Access Compliance Report

Public Rights-of-Way

(Curb Ramps)

Intersection ID: 11164	Main Street: CAMP_GREENE_ST	Cross Street: FREEDOM_DR	Location: NE
ADA ID: 318B0317A8F5	Ramp Type: Perp	Initial Pass/Fail: Fail	Overall Compliance: No
Severity Score: 12.5			
Codes/Mitigation Info/Possible Solution		Field Measurements/Component Compliance

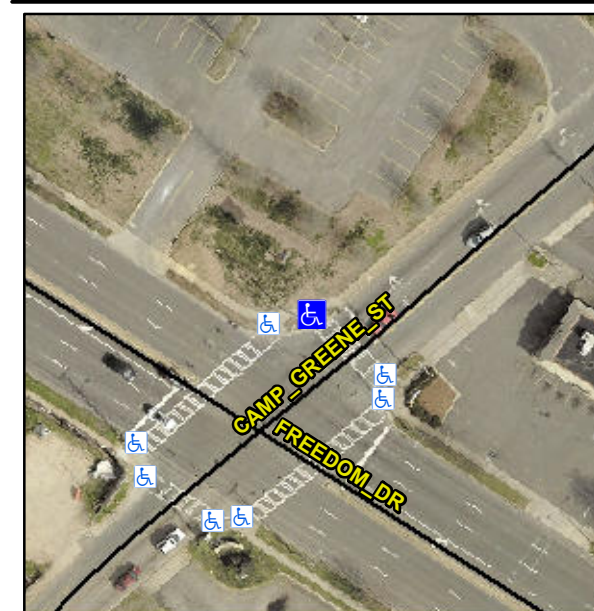
Not Found, R304.2.2

Compliance	Description	Data	Compliance	Description	Data
N/A	Ramp Length (in)	77.0	No	Ramp Slope (%)	10.0
Yes	Ramp Width (in)	48.0	Yes	Ramp XSlope (%)	1.6
N/A	Flare Type LT	N/A	N/A	Flare Type RT	N/A
N/A	Flare Slope LT (%)	N/A	N/A	Flare Slope RT (%)	N/A
N/A	Flare Traversable LT?	N/A	N/A	Flare Traversable RT?	N/A
N/A	Landing Length (in)	N/A	N/A	DWS Provided?	N/A
N/A	Landing Width (in)	N/A	N/A	DWS Contrast?	N/A
N/A	Landing Slope (%)	N/A	N/A	DWS Length (in)	N/A
N/A	Landing X Slope (%)	N/A	N/A	DWS Full Width?	N/A
N/A	Landing Curb? (Y/N)	N/A	N/A	DWS Offset (in)	N/A
N/A	Shared Landing?	N/A			
N/A	Gutter Ponding?	N/A	N/A	Gutter Slope (%)	N/A
N/A	Gutter Lip Ht (in)	N/A	N/A	Gutter X Slope (%)	N/A
N/A	Painted X Walk1?	Yes	N/A	Painted X Walk2?	N/A
	X Walk 1 Direction	To SE		X Walk 2 Direction	N/A
N/A	X Walk 1 Width (in)	95.0	N/A	X Walk 2 Width (in)	N/A
	X Walk 1 Slope (%)	0.5		X Walk 2 Slope (%)	N/A
	X Walk 1 X Slope (%)	2.5		X Walk 2 X Slope (%)	N/A

Remove & Replace Entire Ramp.
